Subject: RGV O1-O3

O-1: Reduced overall length of fencing requirement (See annotated start and stop locations). Fencing alignment should follow the proposed fence alignment recently approved by IBWC indicated in yellow on the attached documentation. However, a roadway to link the proposed fence alignment with notional (b) (7)(E) locations is required in line with the original fence alignment indicated in red on the attached documentation.

Attached are my notes (with note input from (b) (6), (b) (7)(C)) and mark-ups on the O-1, O-2, and O-3 Fence Segments per our "RGV Total Mission Planning" Meeting.

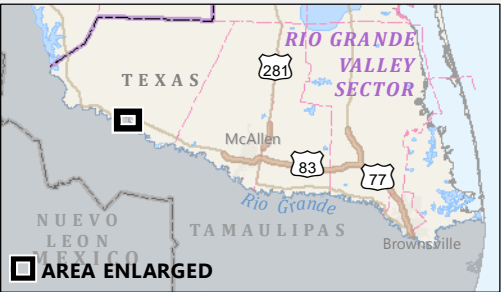
O-2: Reduced overall length of fencing requirement. Fencing alignment should follow the proposed fence alignment recently approved by IBWC indicated in yellow on the attached documentation. However, a roadway to link the proposed fence alignment with notional (b) (7)(E) locations and/or lateral mobility is required in line with the original fence alignment indicated in red on the attached documentation

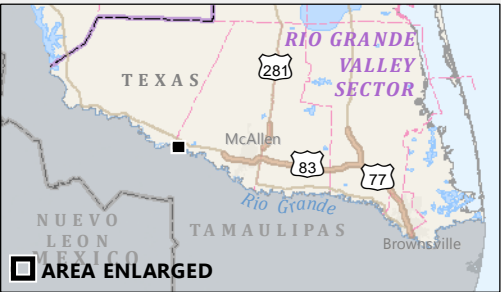
O-3: Eliminate fencing requirement for O-3 provided roadway can be provided in line with original or proposed fence alignments.
